2007-166 R and S Development District No. 1

A RESOLUTION TO EXTEND THE SPECIAL EXCEPTIONS PERMIT FOR A PLANNED UNIT DEVELOPMENT (FORMERLY KNOWN AS THE COVENANT) NOW REFERRED TO AS PERRY NORTH PLANNED UNIT DEVELOPMENT, AND REFERENCED IN CITY COUNCIL RESOLUTION NUMBER 26069, ON TRACTS OF LAND LOCATED IN THE 1000 BLOCK OF DALLAS ROAD.

RESOLUTION NO. 26069

CASE NO.: 2007-166

DALLAS ROAD SUBDIVISION
FOR
R & DEVELOPMENT
1014 DALLAS ROAD
CHATTANOGGA TRI 2700E

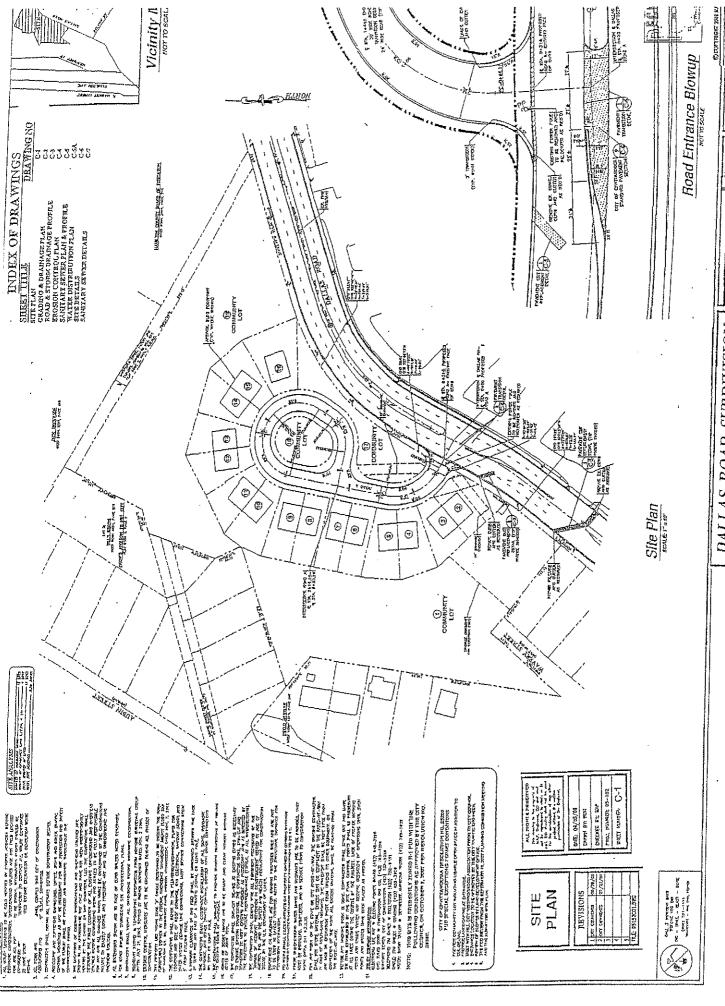
1. Redraw the plat to the 30" x 24" size and format in Appendix 3 of the Chattanooga Subdivision Regulations. This is the only size and format that can be recorded.

- 2. Delete all notes, index to drawings and statements.
- 3. Note that the present zoning is R-1.
- 4. Note that the density is 2.63 units per acre.
- 5. Note the deed references for the P.U.D.
- 6. Add the following note: "Public sanitary sewers are available by gravity flow".
- 7. Add the following note: "Local Government does not certify that utilities or utility connections are available".
- 8. Show the areas of all lots. This could be done in a table.
- 9. Note the total P.U.D. area. The plan shows 5.7 acres.
- 10. Change 15' Drainage Easements in Lots 2 and 17 to 15' Private Drainage Easements.

- 11. Show a 15' Private Drainage Easement in Lots 11 and 12 along the drainage pipe from yard inlet YI #2 to the road right-of-way.
- 12. Give the Road "A" a name approved by the GIS Department. The GIS Department has approved Ringhill Circle as a street name.

- 13. Show street addresses per the GIS Department.
- 14. Add the following note: "The only minimum building setback required is 25' from Dallas Road right-of-way, and other outer boundaries of the P.U.D., minimum 10' from the internal road and minimum 10' between free-standing buildings. Other than above, no minimum building setbacks are required".

- 15. Show the beginning and ending points of curved right-of-way lines. Show length, radius, tangent distance and delta angle for all curved road right-of-way lines.

- 16. Show bearing and distance for all straight right-of-way lines, the rear lines of Lots 2-16 and the side lines of Lots 2-16 where no building is proposed.

- 17. Note a typical lot number.
- 18. Delete station numbers and point of curve and point of tangent numbers.
- 19. Label road center lines as such.
- 20. Add the following ownership statement and have it signed by the owner: "I certify that I am the owner in fee simple of the property shown, adopt this as my plan of planned unit development, dedicate the road right-of-ways as shown to the public use forever and certify that there are no encumbrances on the property dedicated". Show the name, address and phone number of the owner.

- 22. The developer should be aware that Article 5, Division 25, Section 38-402 (1c) of the Chattanooga Zoning Ordinance requires that the location of all structures except detached single-family houses must be shown on a P.U.D. Consequently,

- 26. Resolution No. 25280, which approved the Preliminary P.U.D. Plan, required the following: "Provide landscaping at entrance". Consequently, show the landscaping to be provided at the entrance to comply with Resolution No. 25280.

- 27. Resolution No. 25280, which approved the Preliminary P.U.D. Plan, required the following: "Provide community lot including usable open space in addition to cul-de-sac". In order to conform to this requirement, add the following note: "Per Resolution No. 25280, no residential, commercial or industrial building is permitted on Community Lots 1 and 18. Community Lots 1 and 18 are to be used for open space, drainage, drainage detention, recreation and community purposes only".

- 28. Per Resolution No. 25280, show the location and file number of the existing sewer line in Dallas Road.
- 29. Per Resolution No. 25280 and Article 5, Division 25, Section 38-402(1c) of the Chattanooga Zoning Ordinance, show the location of all parking areas.

- 30. Per Resolution No. 25280 and Article 5, Division 25, Section 38-402 of the Chattanooga Zoning Ordinance, show the location of proposed sewer lines and manholes.

- 31. Per Article 5, Division 25, Section 38-401 (1f) of the Chattanooga Zoning Ordinance, "any change to the location of access" is a major change. Since no entrance was shown to Dallas Road from the proposed dwellings on the plan approved by Resolution No. 25280, add the following note: "Per

- 32. Add the following note: "Only a detached, single-family dwelling, accessory uses and community uses are permitted on Community Lots 17 and 19".
- 33. Per Article 5, Division 25, Section 38-397(3) of the Chattanooga Zoning Ordinance, and Resolution 25280, sidewalks are required along Road "A" (Ringhill Circle) except at Community Lot 18. The plan approved by City Council in Resolution No. 25280 shows sidewalks along Road "A" (Ringhill Circle). Article 5, Division 25, Section 38-397(3) of the Chattanooga Zoning Ordinance requires that sidewalks must be a minimum 5' wide. Consequently, show a minimum 5' wide sidewalks along both sides or Road "A" except for the frontage of Community Lot 18.

- 35. Show a 20' public sanitary sewer easement in Lot 2 along the proposed sewer line.
- 36. Add the following note: A 10' private drainage easement is reserved along the outer boundaries of this P.U.D. except Dallas Road frontage. This drainage easement is automatically abandoned if two or more lots are combined or used as one lot or no setback is required".

- 39. Change "Drainage Easement for Detention Pond" to "Private Drainage Detention Area Easement and City of Chattanooga Inspection Access Easement".
- 40. If there is to be a Road Entrance Blowup, show the road name for Road "A", sidewalks locations and the landscaping required at the entrance by Resolution No. 25280.

- 41. Note that the tax map numbers as 126L-C-005, 126M-G-003 through 008 and 126M-G-014 through 018.
- 42. Show adjoining lot numbers, lot lines, subdivision name and plat book and page numbers for adjoining Lots 32-40, 59 and 60 in Highland Pines, Plat Book 11, Page 36 west and south of Community Lot 1 per Resolution No. 25280.

- 43. Show adjoining lot numbers, subdivision name and plat book and page number for adjoining Lots 32-37 of Crow's Addition to Hill City, Plat Book 2, Page 7, north of Community Lot 1 and west of Community Lot 19, per Resolution No. 25280.

- 44. Add the following note: "This plat abandons all interior lot lines of lots in this P.U.D. not shown".
- Per Article 5, Division 25, Section 38-402(1b) of the Chattanooga Zoning Ordinance, add the following note: "Adjoining Lots 39 and 40 of Highland Pines Zoned R-3 and occupied by an apartment. Adjoining Lot 60 of Highland Pines Zoned R-2. All other adjoining property Zoned R-1".

- 1. Add the following note: "The City of Chattanooga reserves the right to access at any time the Private Drainage Detention Area Easement and City of Chattanooga Inspection Access Easement in Community Lot 1 to inspect drainage detention areas and facilities".
- 2. Covenants are required which specify that all lot owners are responsible to maintain drainage detention areas and facilities. The Mylar copy of the Final P.U.D. plan cannot be recorded until the Chattanooga Development Director has approved the proposed covenants.

- 1. In designing the landscaping at the entrance required by Resolution No. 25280, please be aware that only small shrubs and grass are permitted in the public sanitary sewer easement in Lot 2.
- 2. No structure of any kind, including subdivision entrance signs, is permitted in the 20' public sanitary sewer easement in Lot 2.
- 3. Questions about Chattanooga Sewer requirements should be directed to Mr. Eric Douglas at 643-5814.

- 4. The proposed entrance design in Dallas Road is not acceptable to the City Traffic Engineer. Replace the narrow island proposed for approximately 210' south of Road "A" with a two-way turn lane in Dallas Road. Change the plan to reflect this.

- 1. Show on the plan and install a fire hydrant at Lot 2 and 17 at the entrance but outside the 15' and 25' radius rounded right-of-way at the intersection. Install this fire hydrant on the same side of the road as the water line.
- 2. Show on the plan and install a fire hydrant on the same side of Ringhill Circle as Community Lot 18 opposite the lot line between Lots 13 and 14. Install the fire hydrant in this location even if the water line is on the other side of the road. A fire hydrant at the lot line between Lots 13 and 14 is not acceptable because it is too close to proposed buildings.
- 3. Article 3, Section 302.3.4.2 of the Chattanooga Subdivision Regulations reads, in part, as follows:

Since 24' wide streets are proposed, indicate the parts of Road "A" (Ringhill Circle) that will not have parking to comply with this regulation.

1. At the intersection of Road "A" and Dallas Road, replace the hood and grate with a junction box with manhole cover.

- 2. Install a City standard curb inlet at the north line of Road "A" (Ringhill Circle) at Dallas Road. This facility will intercept water on Dallas Road before the intersection.
- 3. Connect the junction box with manhole and the city standard curb inlet with a 15' reinforced concrete pipe (RCP).
- 4. Questions about Chattanooga Storm Water Management requirements should be directed to Mr. Keith Curtis.

- 1. Show a 15' power and communication easement along Dallas Road.
- 2. Show a 10' power and communication easement along Road "A" (Ringhill Circle) in Lots 2-17.
